Our ref: 07/31

**RE: RESPONSE TO SUBMISSIONS REPORT (RTS)  
MODIFICATION NO. 2 – SHOALHAVEN STARCHES EXPANSION PROJECT  
(MP06\_0228.MOD 2)  
PROPOSED CHANGES TO FERMENTATION AND DISTILLATION PROCESS**

**RE: Revised Air Quality Impact Assessment:  
Section 75W Modification Application –  
Minor Modification to Ethanol Plant,  
As part of Shoalhaven Starches Expansion Project MP06\_0228  
Bolong Road, Bomaderry NSW**

TITLE  
EVAPORATORS AND COLUMNS  
ELEVATION LOOKING SOUTH  
MANILDRA GROUP

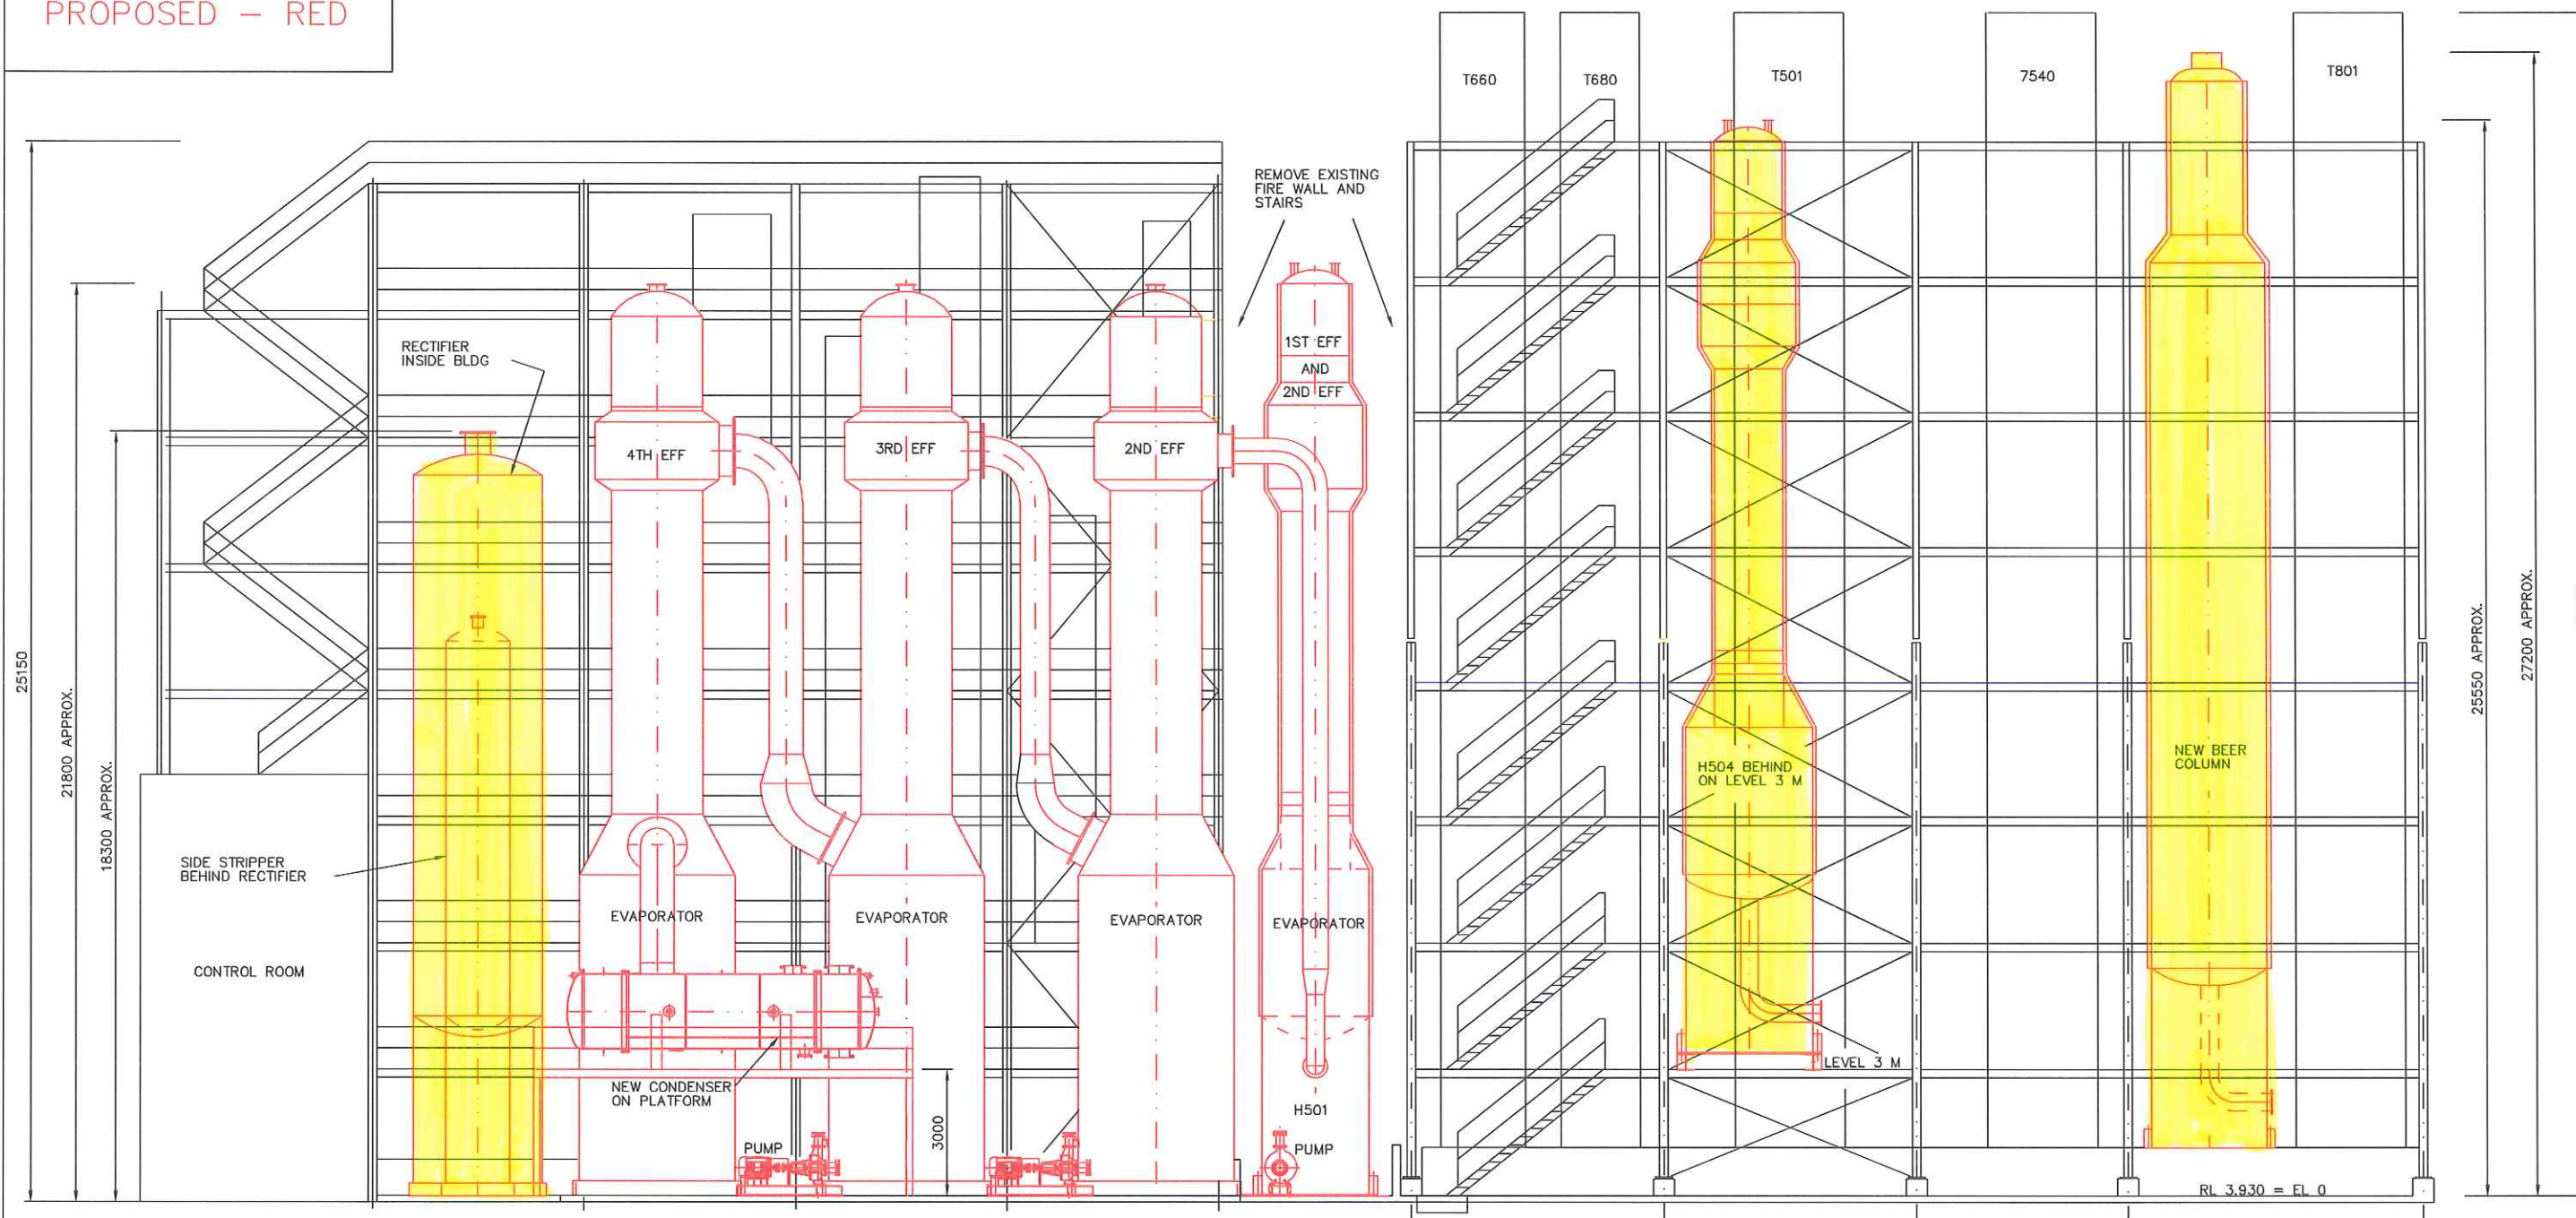
The Department of Planning & Infrastructure in an email dated 24<sup>th</sup> April 2012 requested advice as to the location of the proposed low pressure distillation columns.

Figure 4 in the Modification Application submission shows the works associated with the new distillation columns and evaporator plant. The three new columns are shown as:

- A New "Beer Column" replacing an older Beer Column D10;
- A second new Beer Column is also shown with a new Heat Exchanger (H504); and
- A new Rectifier Column is also shown and will replace an existing older Beer Column. Also shown is a new side stripper that is part of this Rectifier Column.

These new plant are shown on Figure 4 in red; while existing plant is shown black.

To further assist, **Annexure 8** includes the set of plans that support this Modification Application and on which I have highlighted the three columns associated with the distillation plant connected with this modification proposal.
